DOCUMENT CHANGE REQUEST

DCR number	316	Changes required for:	N/A	Originator:	Olivier Masson Chief
Date:	2007/02/01	Date sent:	2007/02/01	Organisation:	CNES
Status:	IMPLEMENTED

Title:	Contacts Power Crimp-Type and Solder Type for 3401/001 and 3401/002 Connectors		
--------	--	--	--

Number:	3401/040	Issue:	3
---------	----------	--------	---

FIGURE 2(c) - PROTRUSION AND RECESS

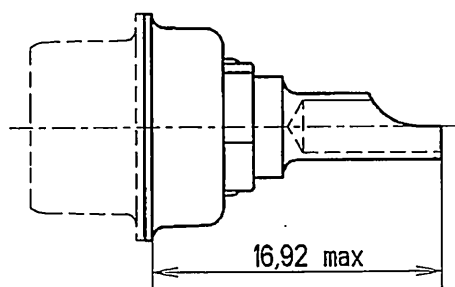
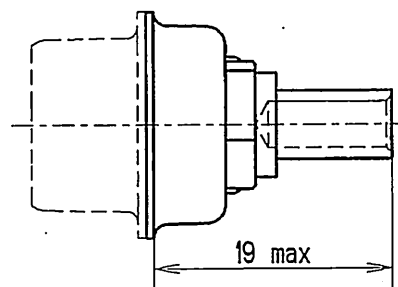
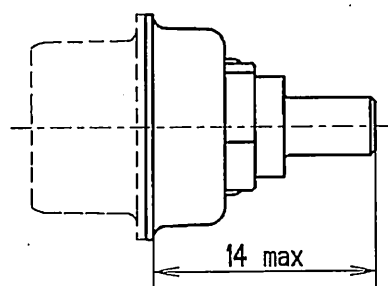
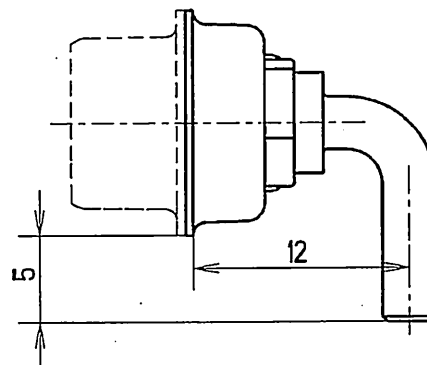
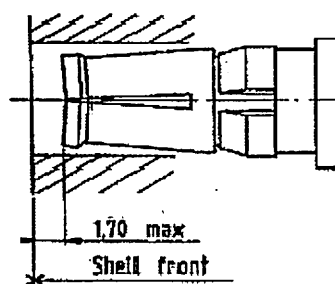
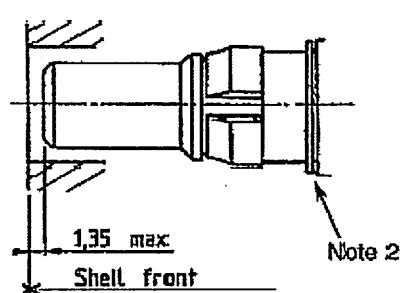
Attachments:
3401040_p13.pdf, 3401040_p10.pdf, 3401040_p12.pdf, null
Modifications:
and the following: 1) Page 1, Spec Title: amend to include " ... AND PCB-TYPE FOR ..." 2) Page 6 & 11, Para 1.1 & 2. Amend titles of 3401/001 & 3401/002 to reflect the latest titles. 3) Page 6, Table 1(a). Manufacturer to advised the maximum weights for new Variants 13 to 16. 4) New Figure 2(c). Figure should be in the same format as used in Fig 2(a) & 2(b) i.e. Dimension letter & Table format. Title should be: "FIGURE 2(c) - STRAIGHT AND 90deg PCB TYPE" 5) Page 10, Fig 2(c) should be renumbered: "FIGURE 2(d)"
Approval signature:
